Re: MP 10_0150 & MP 10_0149 – Graythwaite Concept Plan

I am writing to oppose the Revised Concept Plan lodged on behalf of the Shore School.

Application Number: Concept Plan (MP 10_0149) and Stage 1 Project Application (MP10_0150)
Location: 20 Edward Street, North Sydney
Lot 2 in DP 539853 and part Lot 1 in DP 120268
Proponent: Sydney Church of England Grammar School (Shore)
Council Area: North Sydney Council

Graythwaite submission

View from Bank St residence to Graythwaite site showing the area the west building will cover

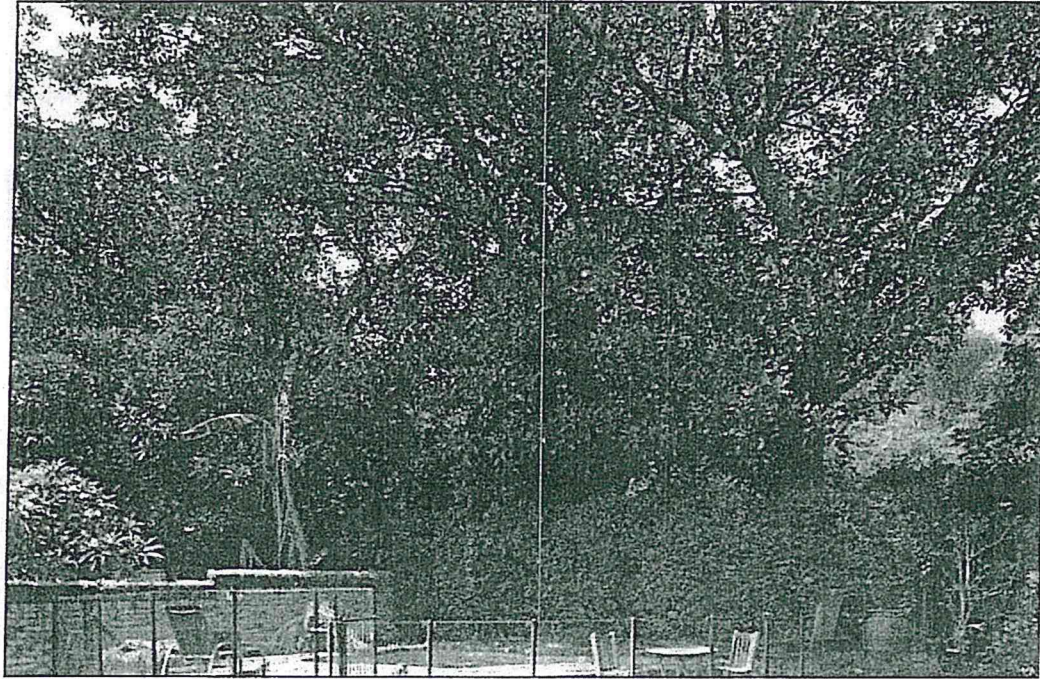
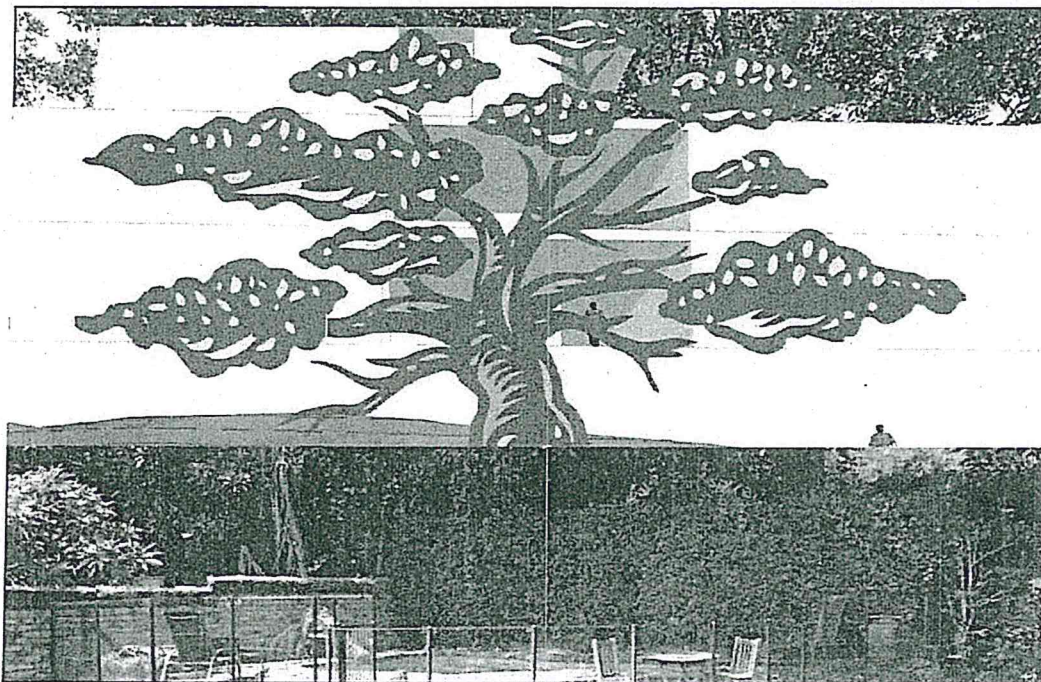
4. Note the open atrium at the centre – this will serve to direct the noise of 500 students towards Bank Street residents.
5. Contrary to the DG requirements there has been no consideration of the surrounding environment, no examination of the loss of view of Bank St residents, no view analysis.

6. Further, in relation to my home the survey is incorrect, both as to the boundary, and in its failure to show our swimming pool (which will be overlooked by 500 students) and the glass atrium on the roof of our house.

7. Any privacy we have enjoyed will be utterly eliminated. The 500 students will look directly into two bathrooms, dining room, kitchen, family room, study, bedroom, and laundry.

8. They will overlook the swimming pool in which our 11 year old daughter plays – rendering it useless when there are students at the school.
9. They will overlook our courtyard and barbeque areas – rendering them useless when there are students at the school.
